ACTION TRANSMITTAL – 2022-03

SUBJECT: Scope Change Request for Hennepin County CSAH 158 (Vernon Ave) Bridge Replacement

To: Metropolitan Council – Transportation Advisory Board (TAB)
From: Jason Staebell, PE – Hennepin County Project Manager
Date: October 20, 2021
Re: CSAH 158 (Vernon Ave) Bridge Replacement Project – Scope Change Request

Figure 1

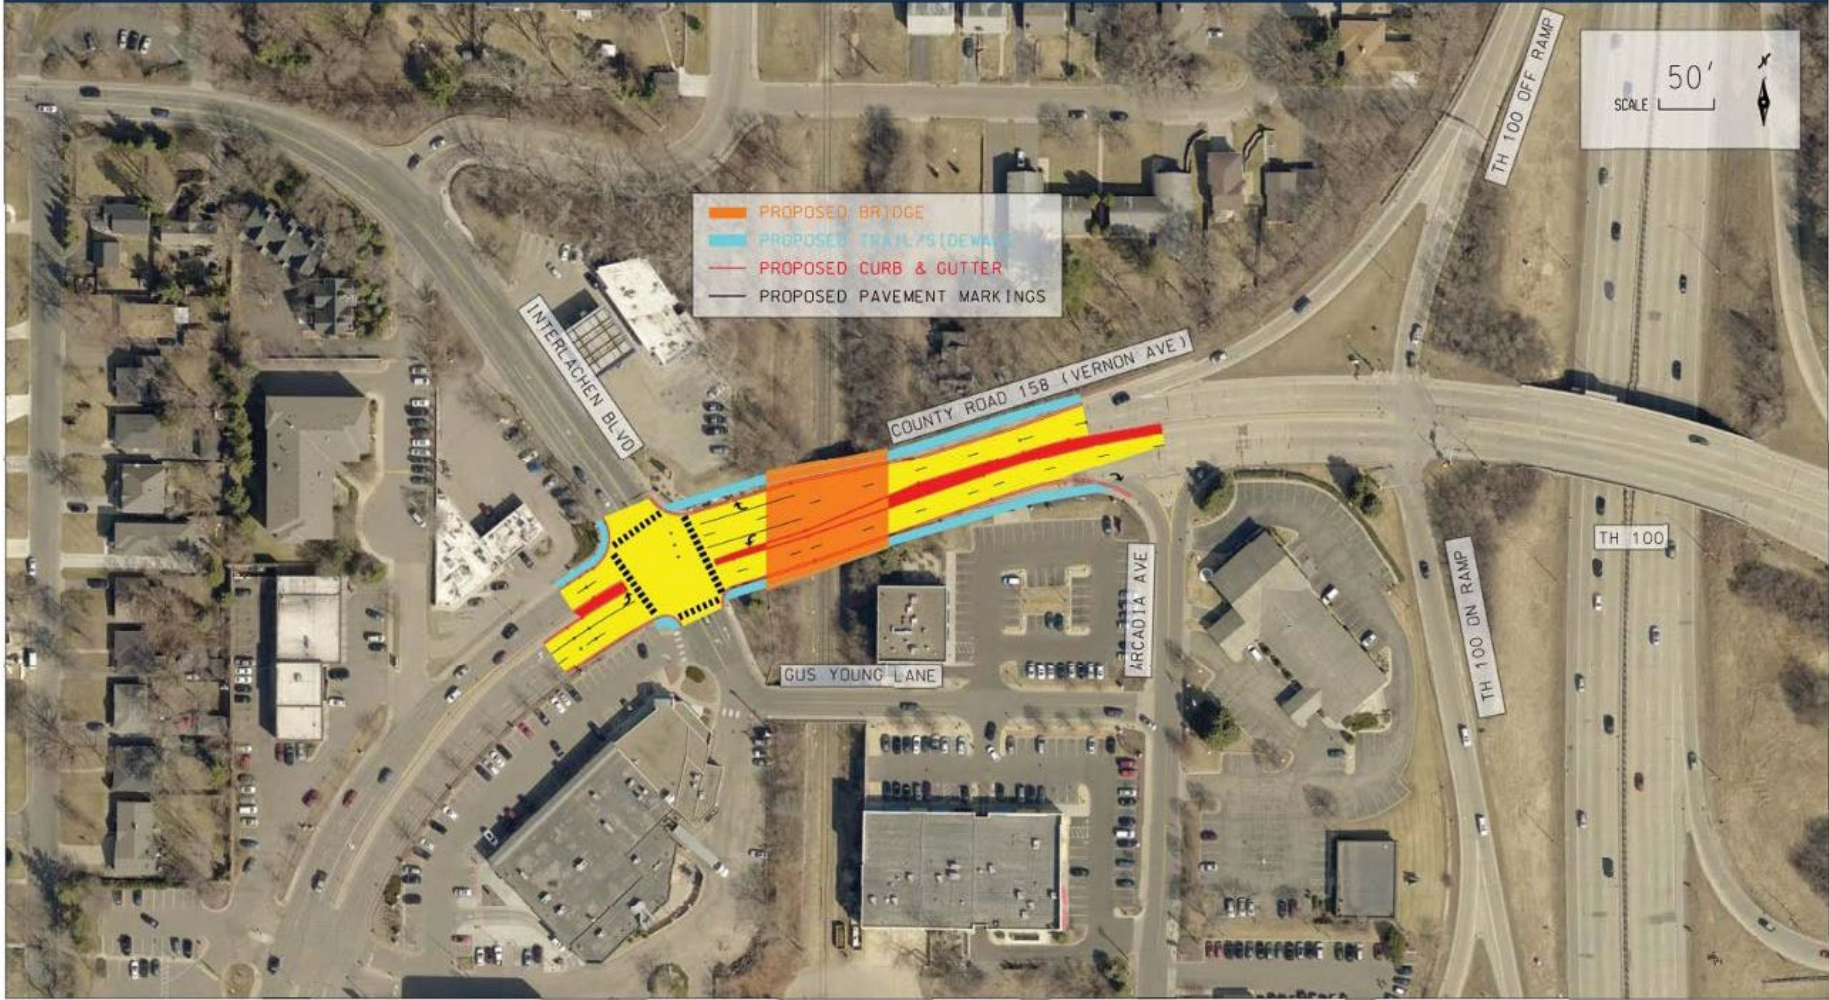
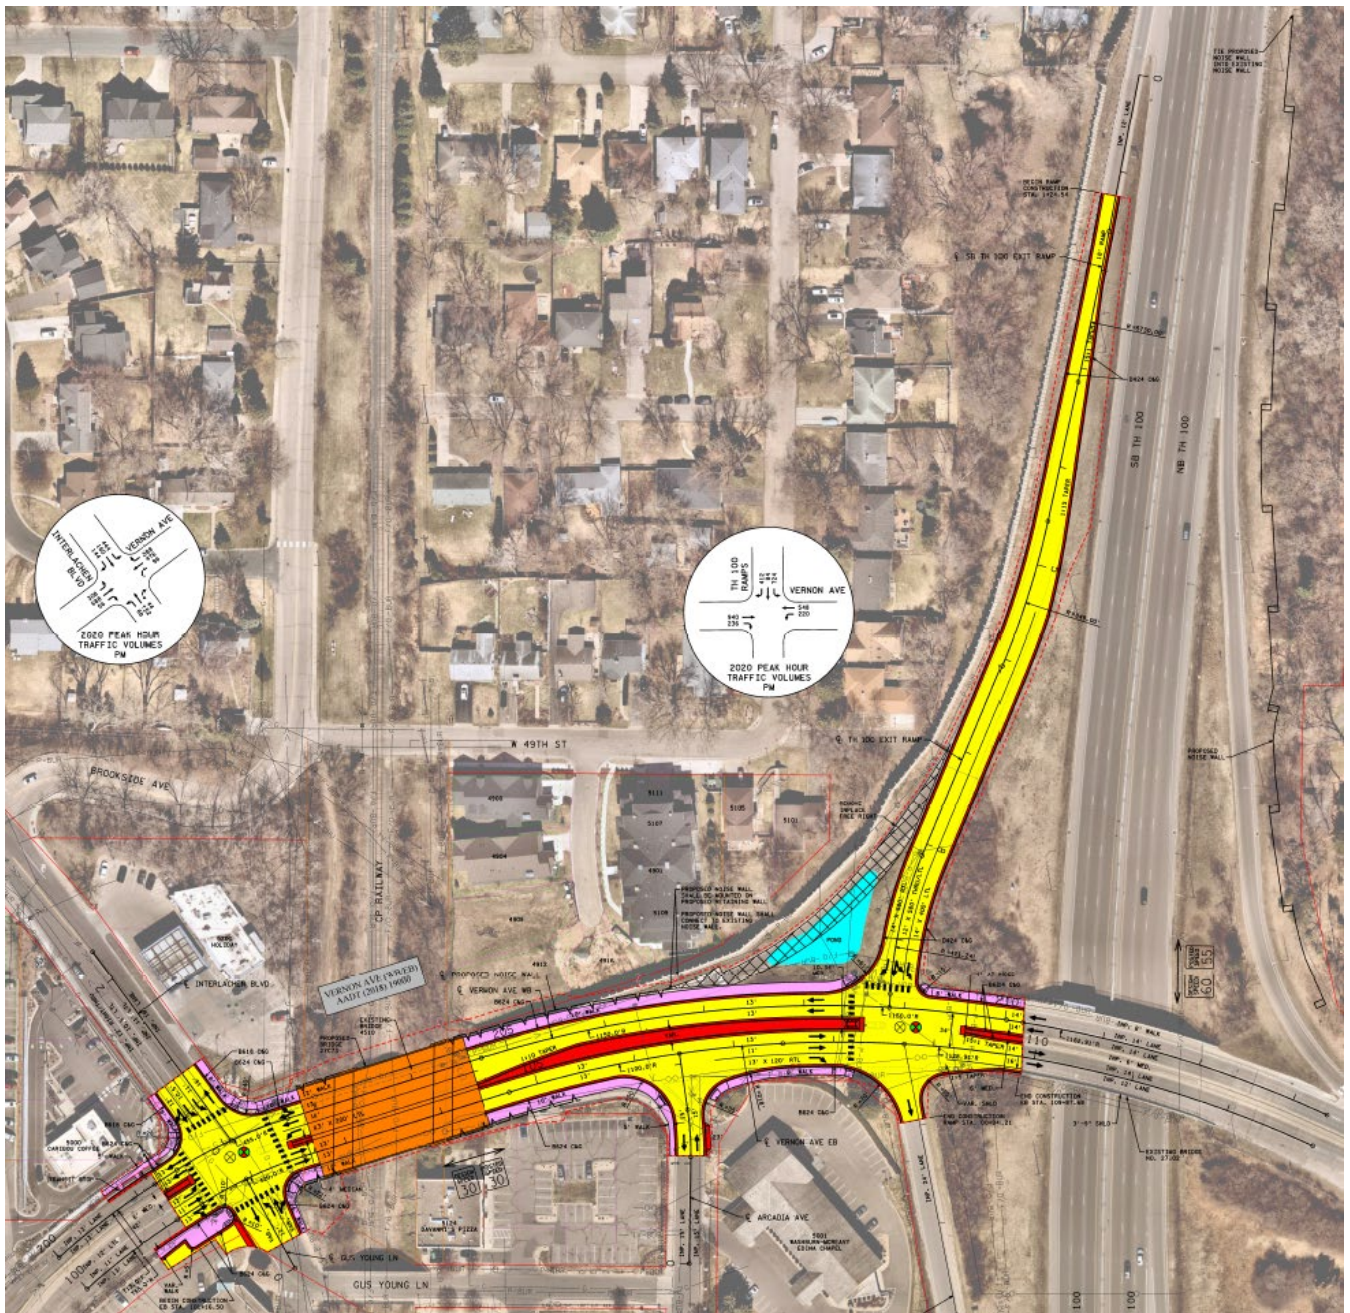
The descriptions below will demonstrate how the aspects of the project that were designed after the 2018 Regional Solicitation Application are still part of the primary purpose of the project and included in “modifications to the roadway approaches that are impacted by the project.” As the preliminary design progressed, impacts to the roadway approaches were found to be greater than originally anticipated.

See Figure 1 for layout of expected scope at the time of the 2018 Regional Solicitation Application. See Figure 2 for a layout of the current scope.

Figure 3: Vernon Avenue WB and EB Profiles

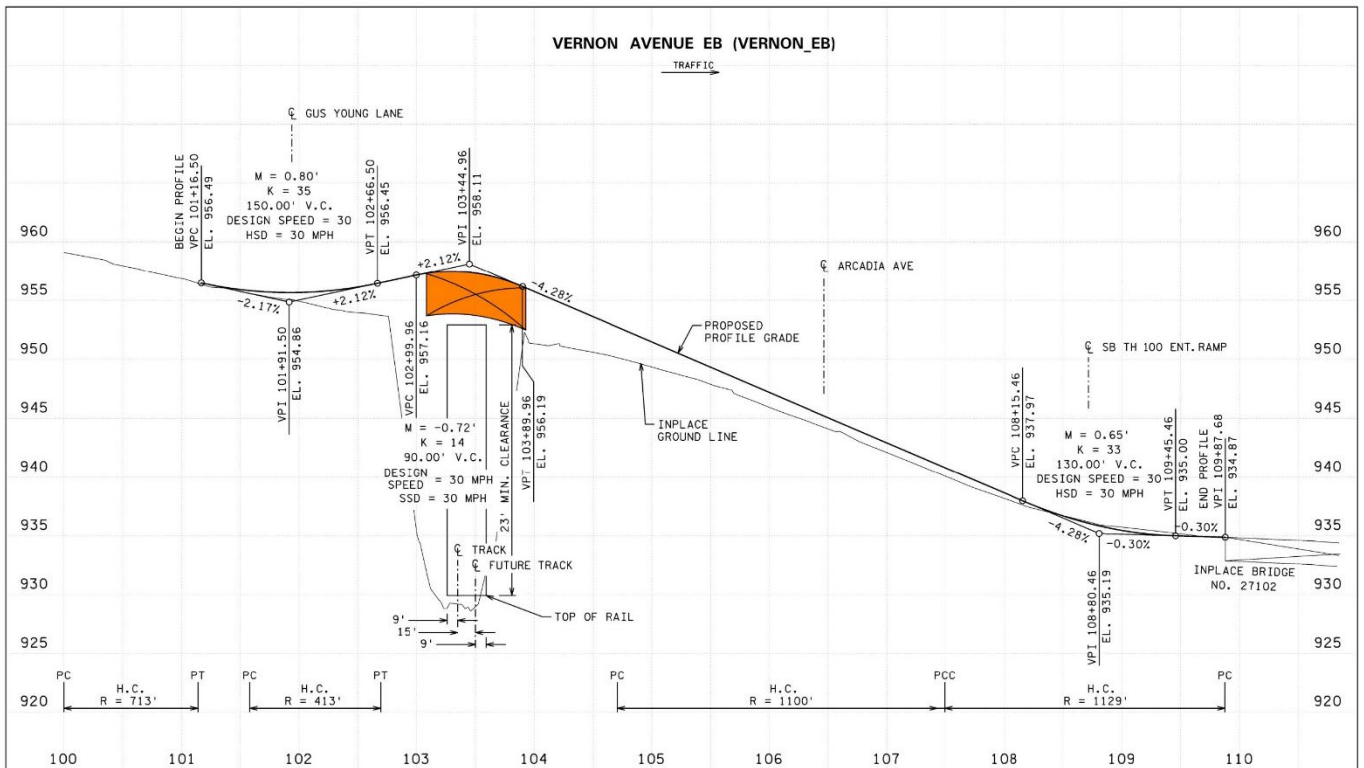
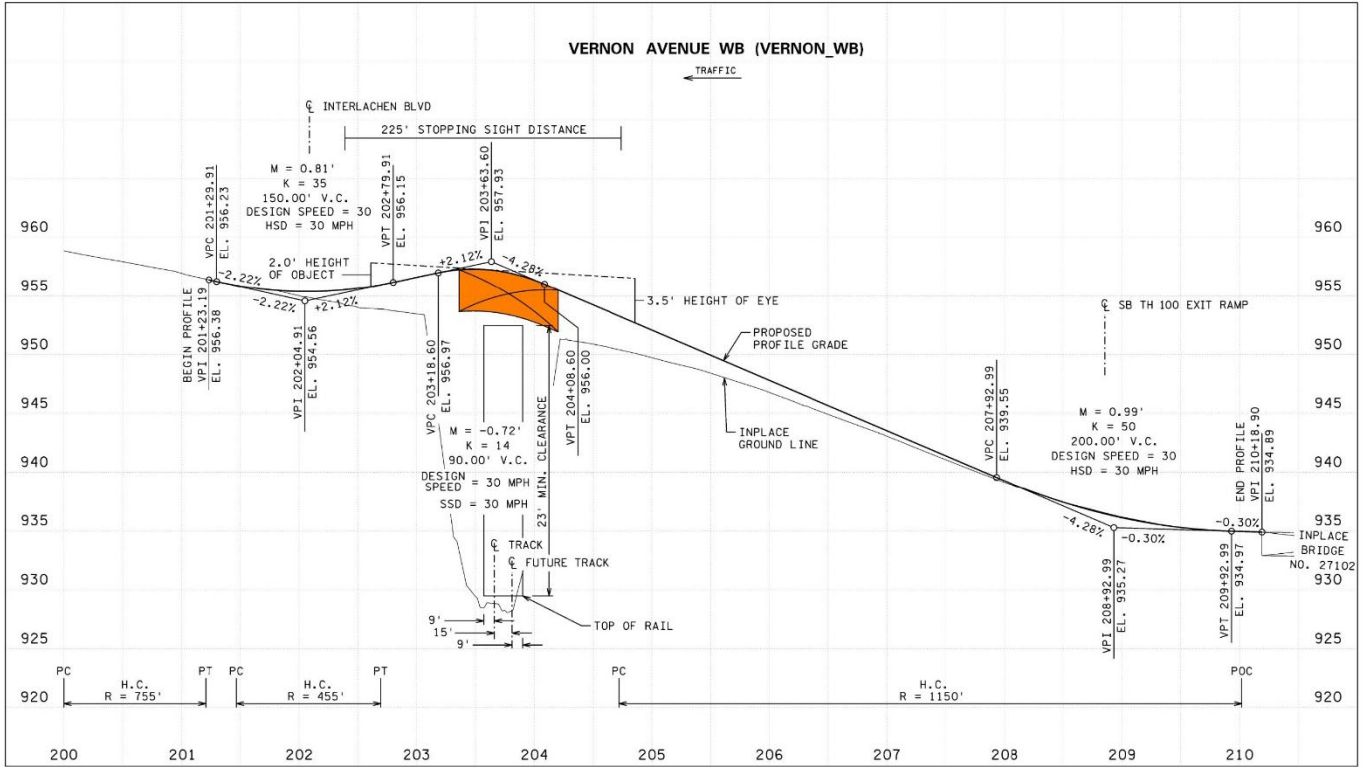
First, profile requirements caused the project to extend to the east. The CP Railway current standards for vertical clearance over their railway required a significant raise in the elevation of proposed Bridge No. 27C73 as compared to the existing 22 foot clearance for Bridge No. 4510. The current preliminary design satisfies the 23 foot minimum vertical clearance requirement over the existing CP railway as well as over a potential future track, which would be located 15 feet east of the existing track (centerline to centerline). The proposed profiles and clearance information can be seen in Figure 3: Vernon Avenue WB and EB Profiles.

On the west side of the project, these proposed profiles were able to tie into the existing roadway at essentially the same location as expected in the 2018 Regional Solicitation Application. However, on the east side of the project, the construction limits needed to extend considerably to the east in order to tie into the built environment. The profile would allow construction to end approximately 26 feet west of the existing bridge over TH 100 (Bridge No. 27102). To be considerate of future maintenance and lifespan concerns, the project was extended this additional 26 feet to match into existing Bridge No. 27102.

Figure 4: Noise Study Required Extents (500' radius)

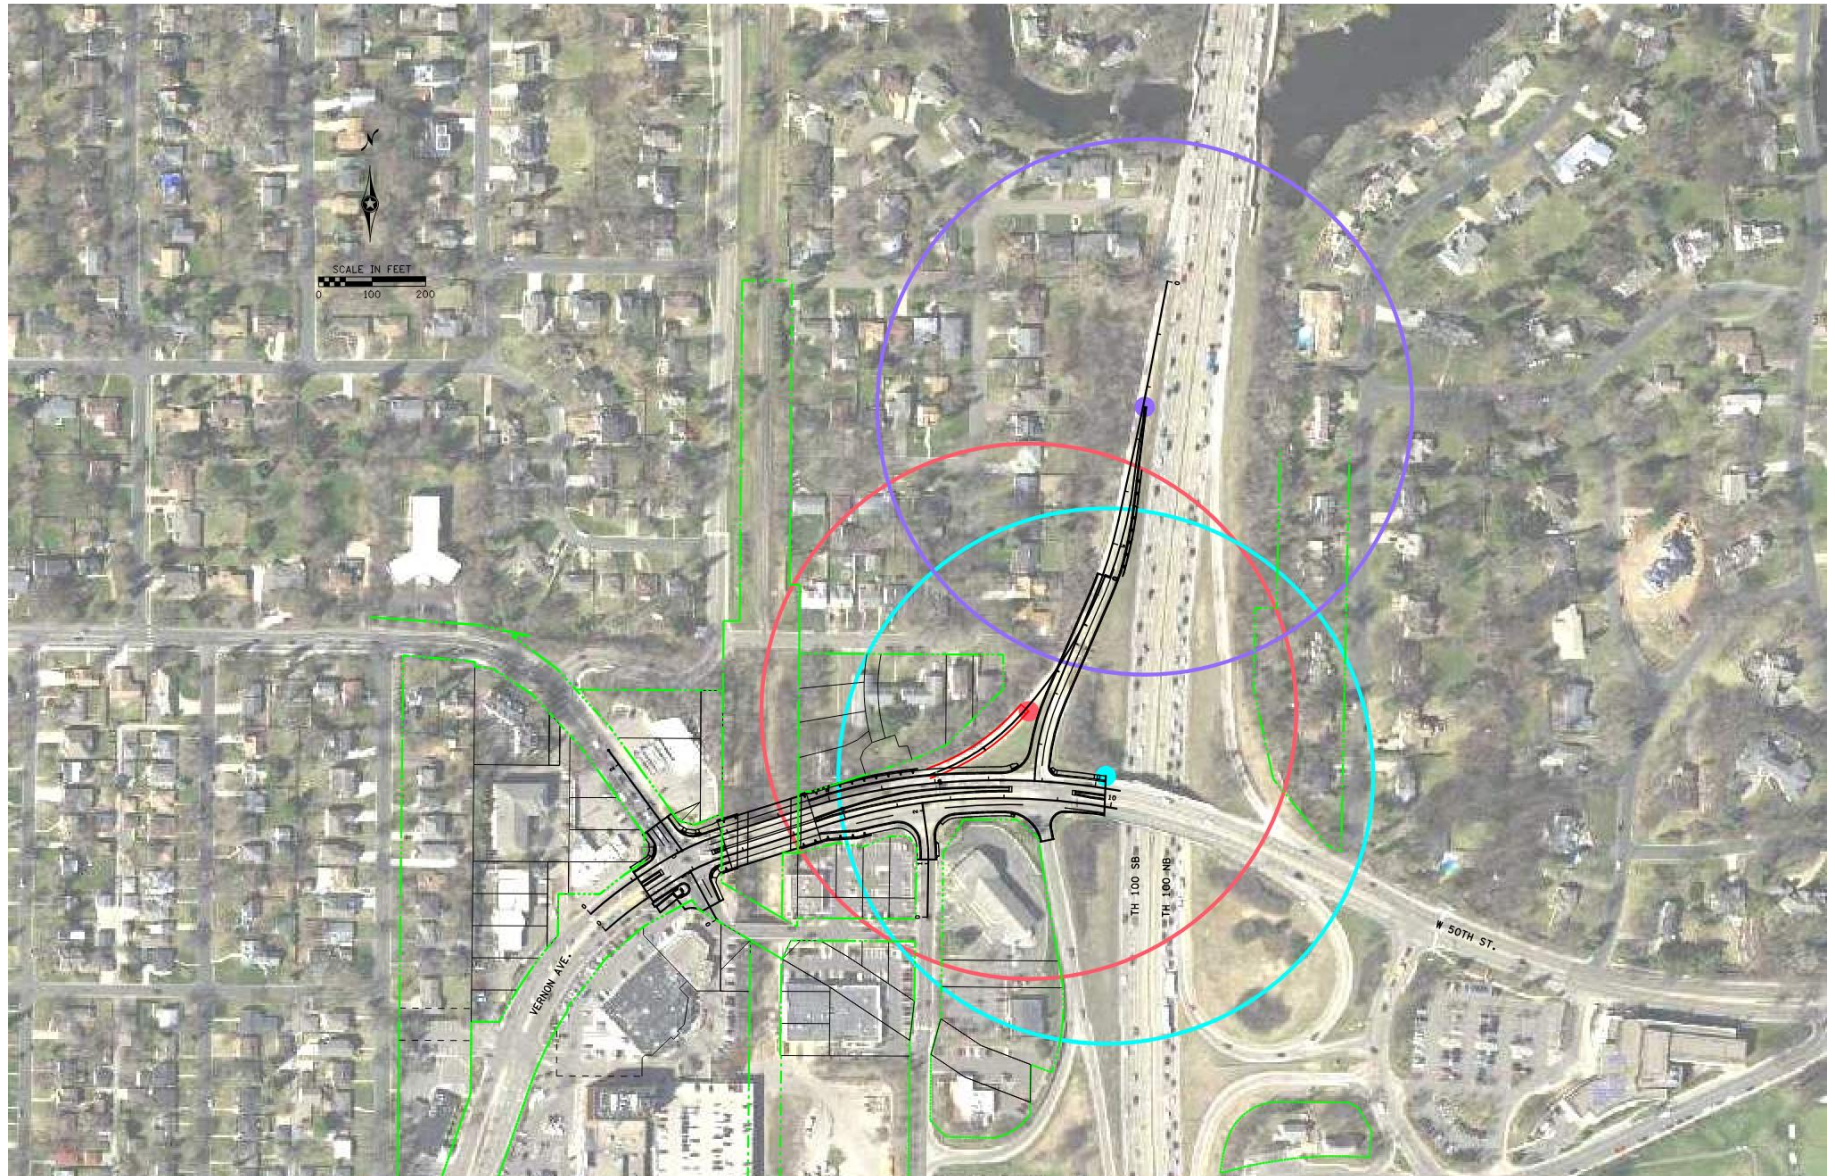
Figure 4 shows the extents of a 500 foot radius from three points, one) the edge of WB Vernon Avenue Construction, two) the edge of construction if the channelized right turn island was reconstructed, and three) the edge of reconstruction of the ramp.

As seen in Figure 4, even disregarding any construction on the SB TH 100 Exit Ramp or channelized right turn island, the noise study would be required to consider the homes just east of TH 100 based solely on the construction of WB Vernon Avenue. Those homes are within 500 feet of the proposed construction.

During the noise analysis, two homes east of TH 100 were found to have noise levels that approached or exceeded the FHWA Noise Abatement Criteria (NAC), which triggered analysis of noise walls in this area. Noise Barrier E, the noise wall modeled east of TH 100 in the *Vernon Avenue Bridge Replacement Project Noise Study*, was found to fulfill the requirements needed for a noise wall to be recommended for construction. First, the barrier is acoustically feasible. Several homes were found to be benefitted with noise reduction of at least 5.0 dBA, and at least one receptor met the required 7.0 dBA noise-reduction design goal. Second, the barrier meets engineering feasibility. A preliminary examination of proposed location did not discover any fatal flaws that would make a noise barrier unreasonable to construct or maintain. Thirdly, the barrier met the cost effectiveness criteria, meaning that the cost per benefitted receptor is not expected to exceed \$78,500.
